Rezoning Application: PD 23-0785
Zoning Hearing Master Date: February 20, 2024
BOCC Land Use Meeting Date: April 9, 2024

The applicant requests to rezone property zoned PD (Planned Development) #85-0317 to PD #23-0785 to develop a 536 unit multi-family project.

APPLICATION NUMBER: PD 23-0785

AGENCY REVIEW COMMENT SHEET

8.0 PROPOSED SITE PLAN (FULL)

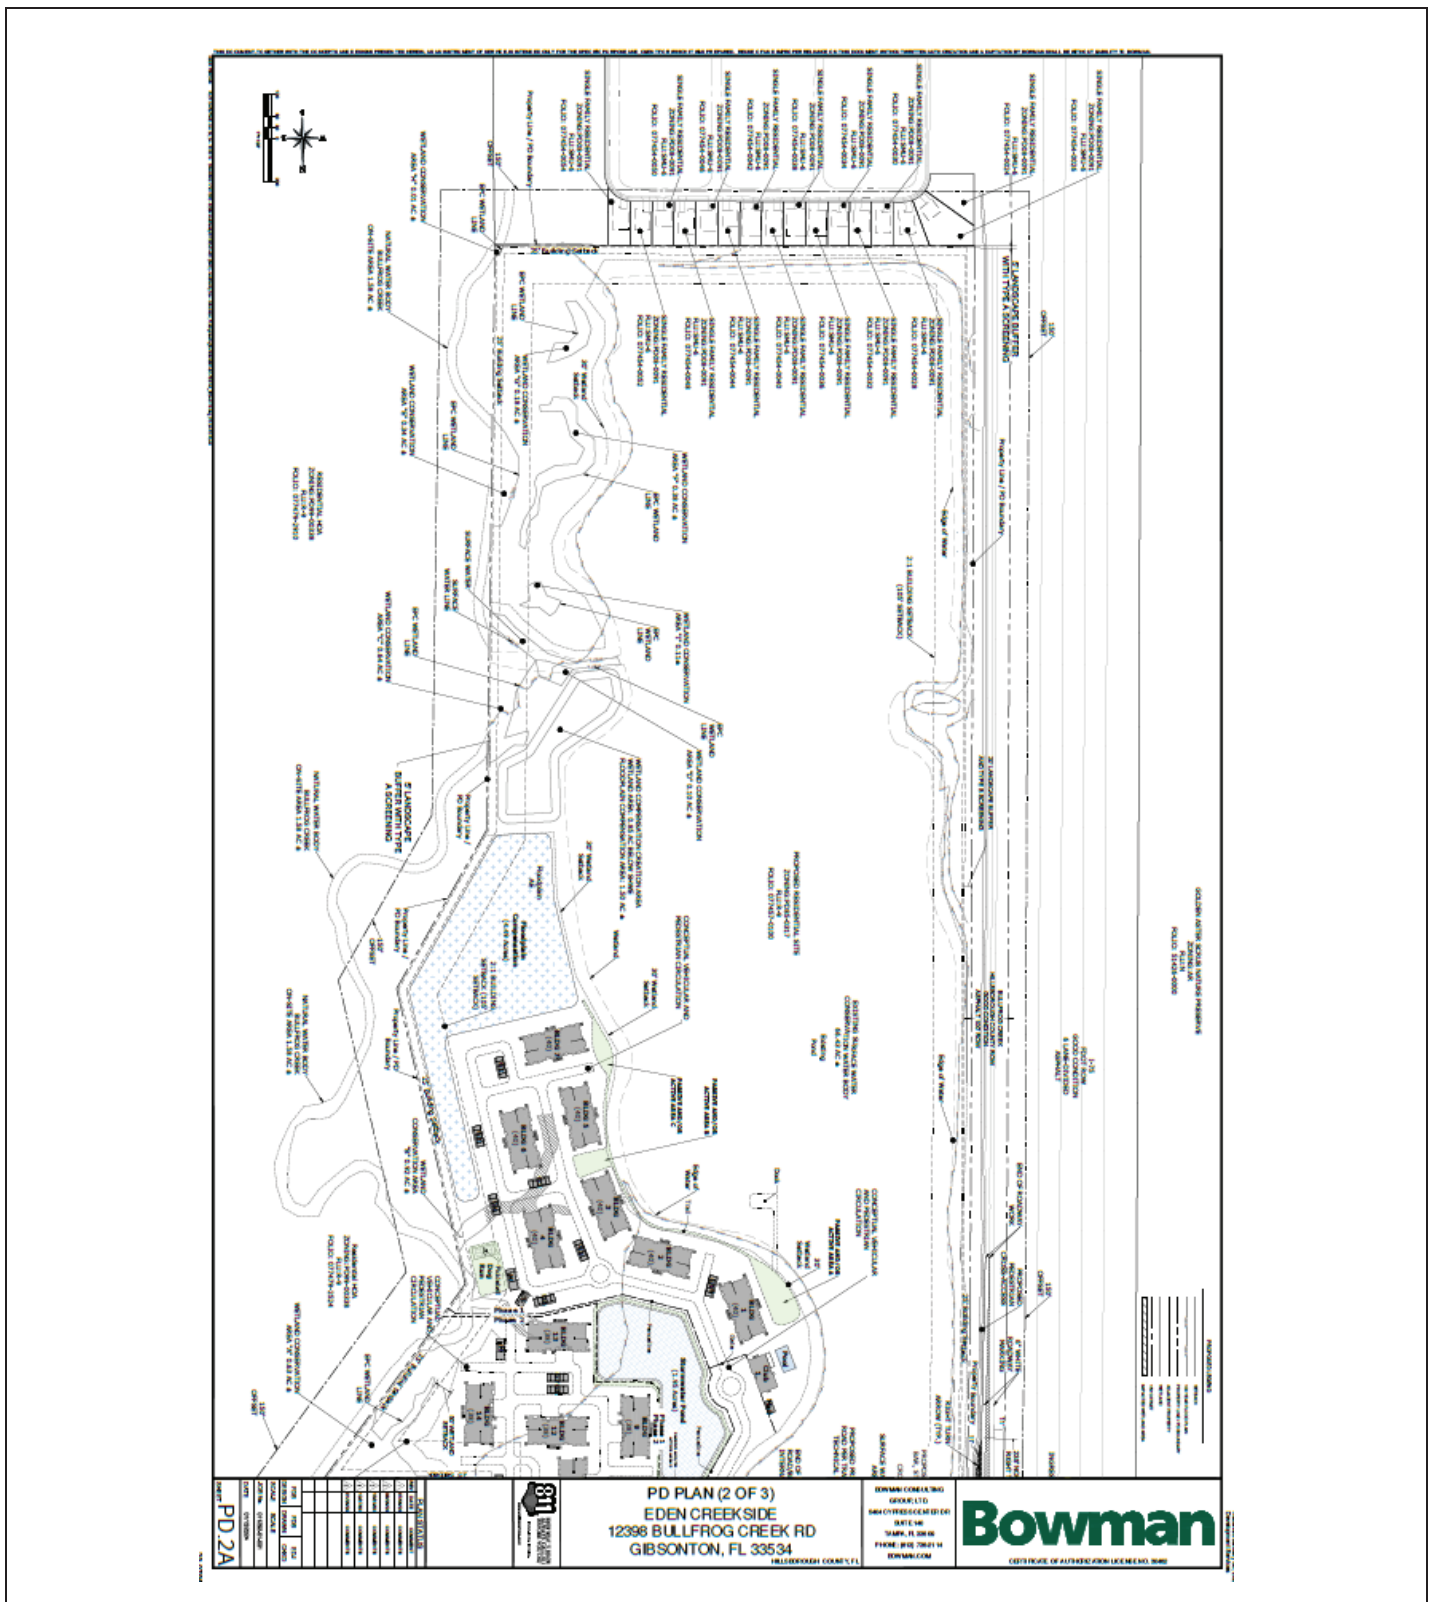
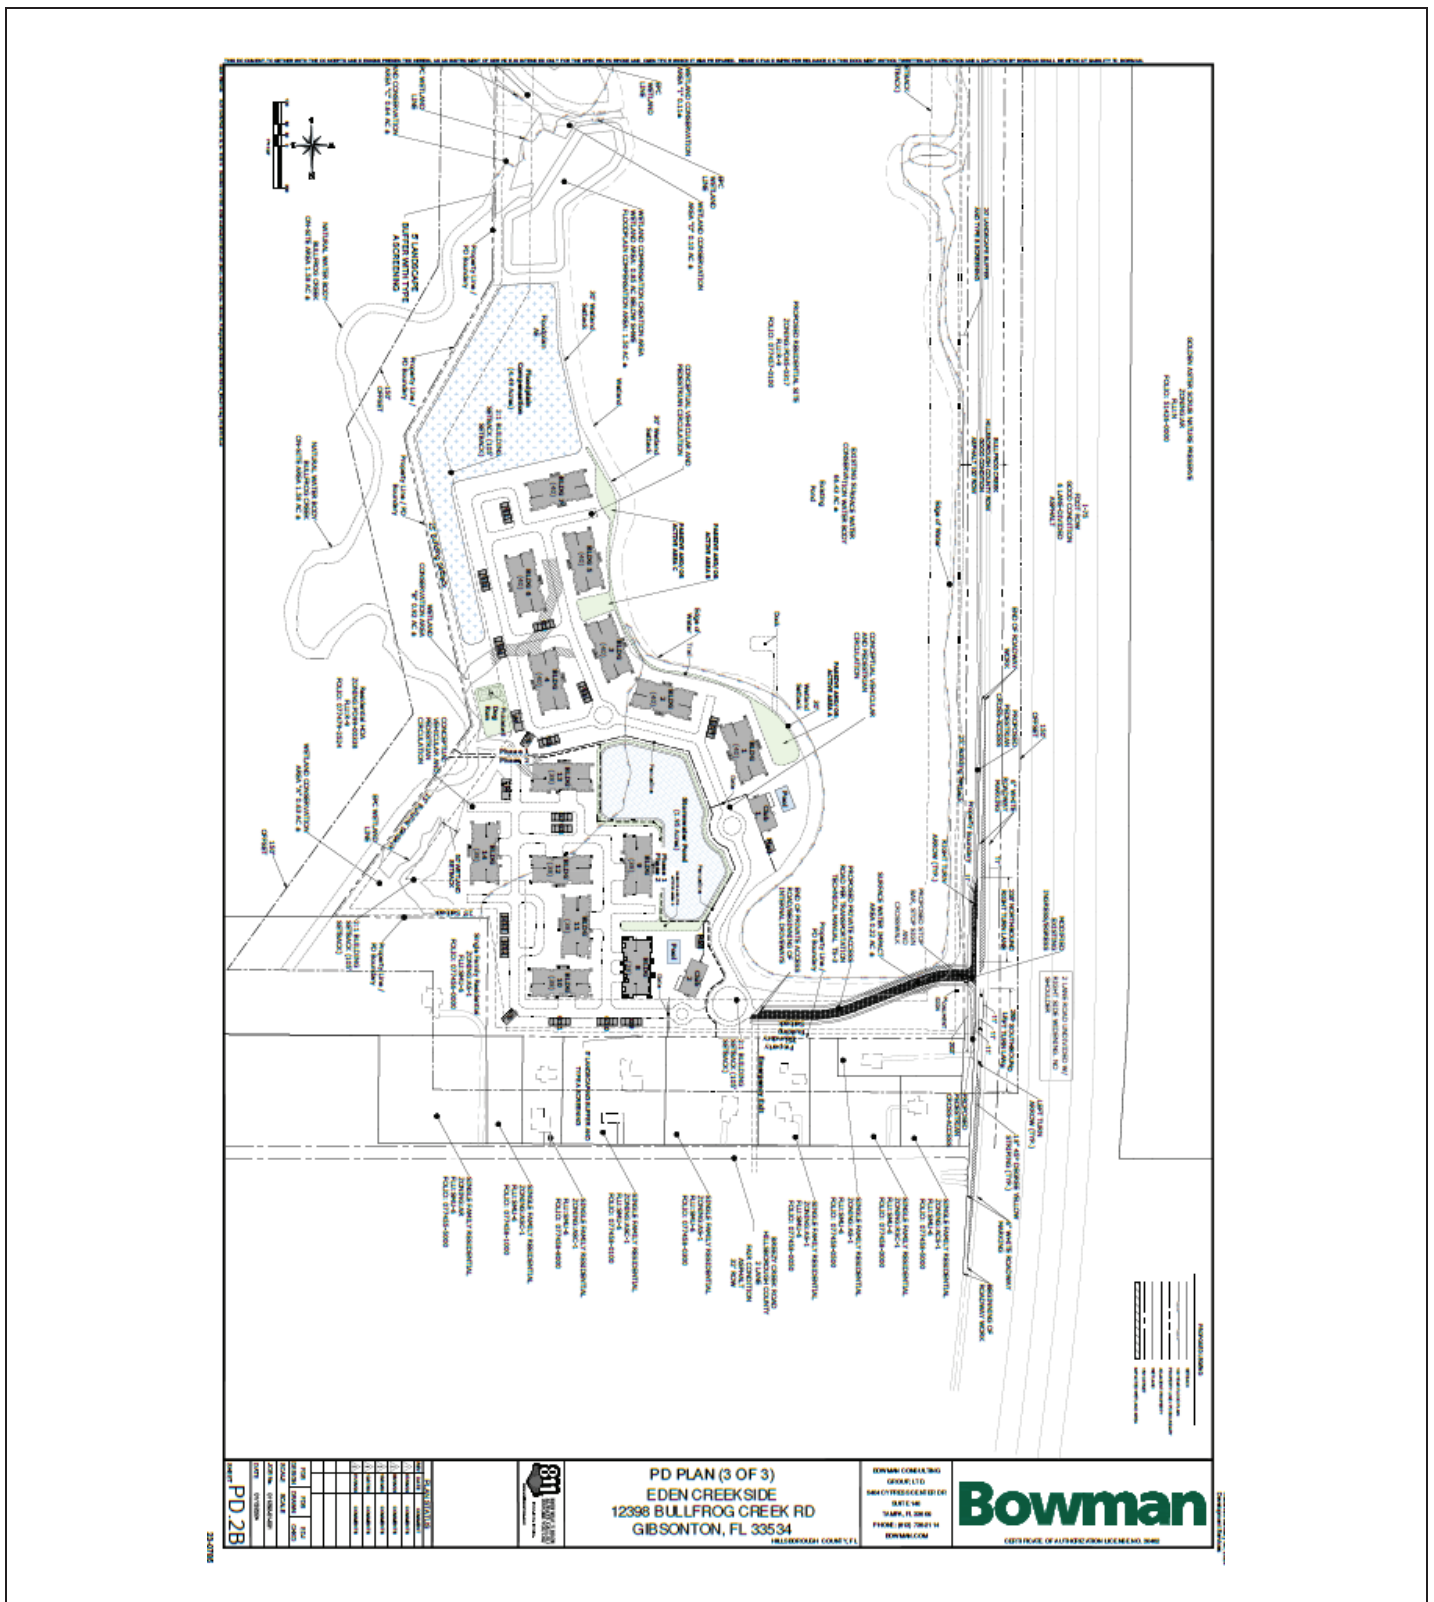
- 1) The developer shall revise the PD site plan to:
 - a) Revise the general statement to reflect correct proposed unit count (it conflicts with the site data table on the same page);

- b) Remove all references to proposed signage (staff notes that signage must be reviewed and permitted separately in accordance with applicable rules and regulations);

- c) Revise General Note 1 to describe the internal roadway as well as the driveways (consistent with proposed condition 4, above).
 - d) Correct existing/proposed sidewalk placement. Staff notes that sidewalk just south of the proposed project is located immediately +/- 2-feet west of the existing right-of-way boundary (see photo below), which is inconsistent with how its drawn on the PD site plan. Also, proposed sidewalk should be located consistent with the conditions proposed hereinabove.

- e) Revise note 10 to add to the end of the sentence “, subject to compliance with the Design Exception and conditions of zoning approval.”
- 2) Site plan to be modified to comply with condition #3.

FIGURE 1
SIDEWALK IMPROVEMENTS 23-0785

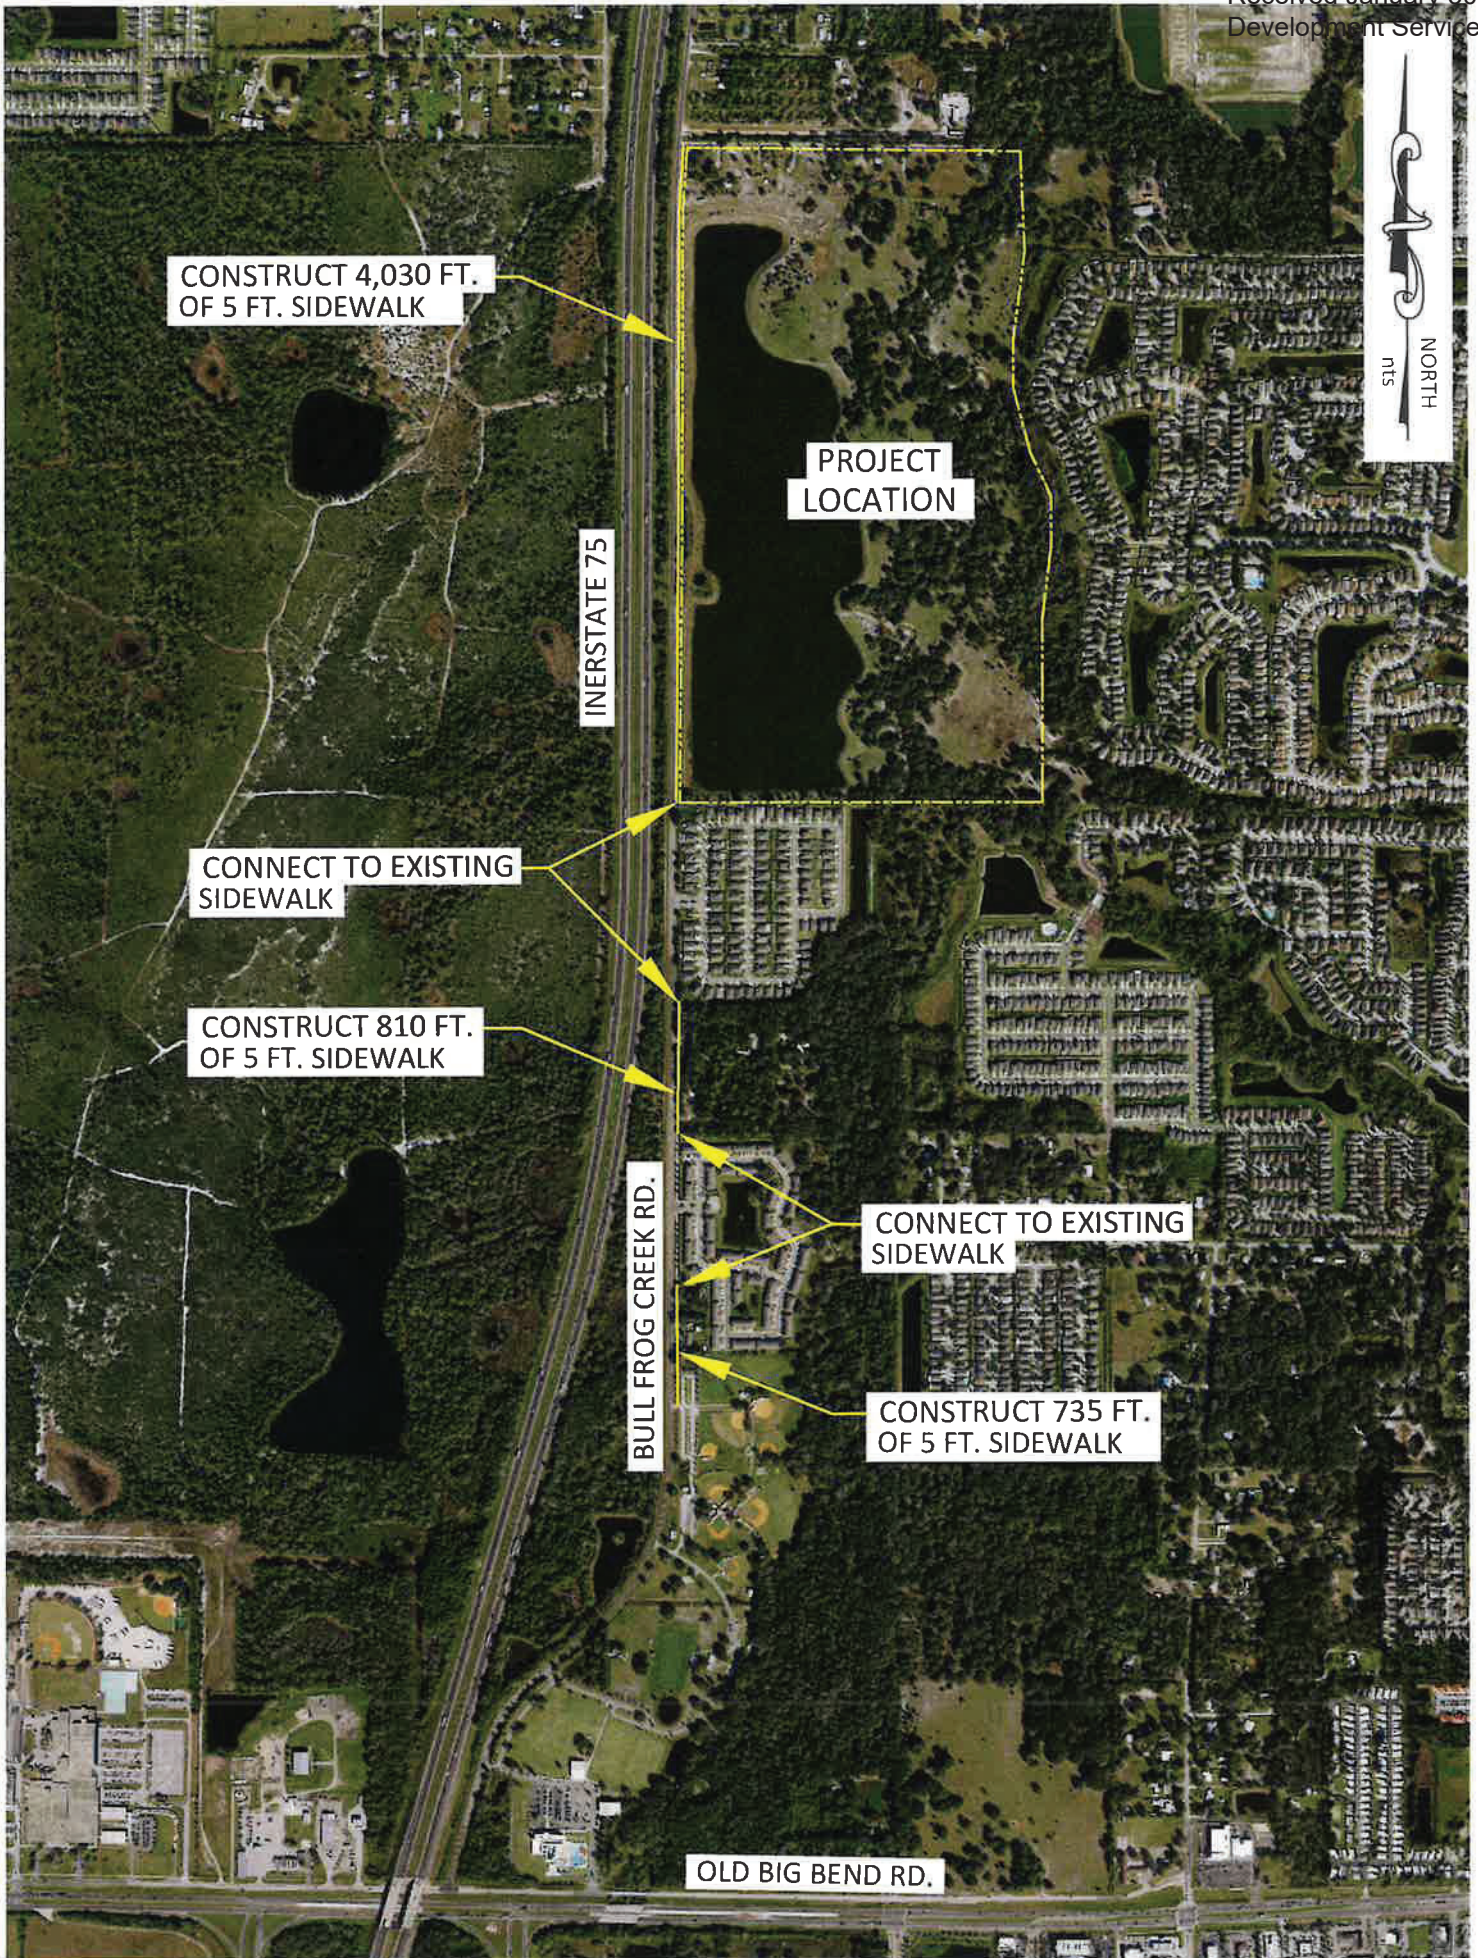
Staff notes that there was an error in the Design Exception (DE) due to the fact that the DE utilized outdated aerials. Because of this, the amount of sidewalk which the applicant will be installing is less than the value indicated in the DE request, since a portion of the area they are proposing to construct sidewalk has already been constructed by another developer. Staff notes that the zoning condition and above summary accurately conveys the extent of the required improvements as of the date of this staff report.

1. Sidewalk – the developer proposes to construct a sidewalk along the east side of the road to provide a continuous sidewalk from the project to the Vance V. Vogel Park. The developer is to construct approximately 4,030 feet of sidewalk along the proposed frontage and then an additional 1,545 feet to fill in the missing segments.
2. The County has plans for a 12 foot trail on the west side of Bullfrog Creek Road. This will allow bike and pedestrian circulation to the park, YMCA and schools in the area.
3. The developer proposed to construct the access improvements along Bullfrog Creek Road with an east side widening that will then allow the planned trail on the west side of Bullfrog Creek Road.

Figure 1 illustrates the proposed sidewalk improvements. With these improvements there will be a continuous sidewalk from the project access to the park entrance.
